MIL-C-39012C
AMENDMENT 5
26 April 1991
SUPERSEDING
AMENDMENT 4
7 June 1990

CONNECTORS, COAXIAL, RADIO FREQUENCY,
GENERAL SPECIFICATION FOR

This amendment forms a part of MIL-C-39012, dated 11 August 1982, and is approved for use by all Departments and Agencies of the Department of Defense.

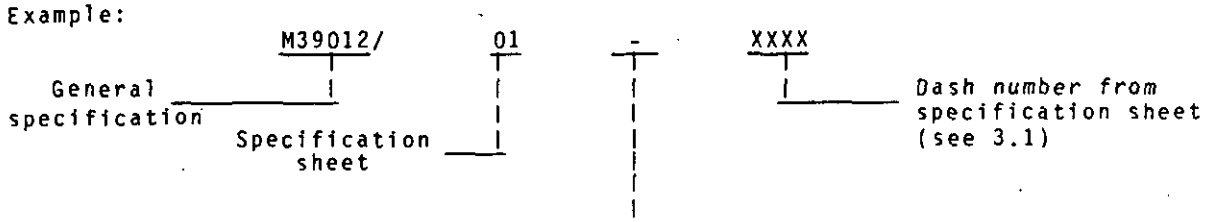
1.2.3, delete and substitute:

"1.2.3 Part number. The part number shall consist of the letter 'M' followed by the basic specification sheet number, and a sequentially assigned four digit dash number. The first digit in the dash number designates the material of the connector body (shell); i.e., '0' for brass, '3' for corrosion-resistant steel; and '4' for copper beryllium.

The '-' designates a standard military part. This position, when filled with the letter 'B' (i.e. M39012/01BXXXX), signifies a military part which is for OEM use only. The part is assembled to the cable with special tooling. Acquisition of this type part by any agency other than OEM's is prohibited and will result in the substitution of the equivalent military replacement part (i.e., if 'M39012/01BXXXX' is submitted for acquisition, 'M39012/01-XXXX' will be recommended)."

FIGURE 6. Safety wire hole pullout procedure.

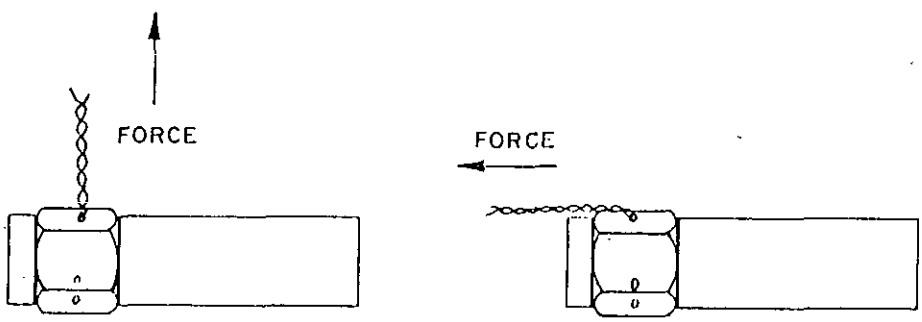
Add figure 6 as follows:

"4.6.25 Safety wire hole pullout (see 3.32). A single strand of safety wire shall be looped through the safety wire hole and secured to itself. Forces of 15 pounds (67 newtons) minimum shall be applied to the safety wire pulling away from the connector. One pull shall be parallel to the connector axis and one pull perpendicular to the connector axis (see figure 6). The safety wire shall be corrosion resistant steel .020 inch diameter (24 gauge) or .015 inch diameter, (27 gauge) in accordance with MS20995. This test is to be conducted under static conditions. All holes are to be tested individually."
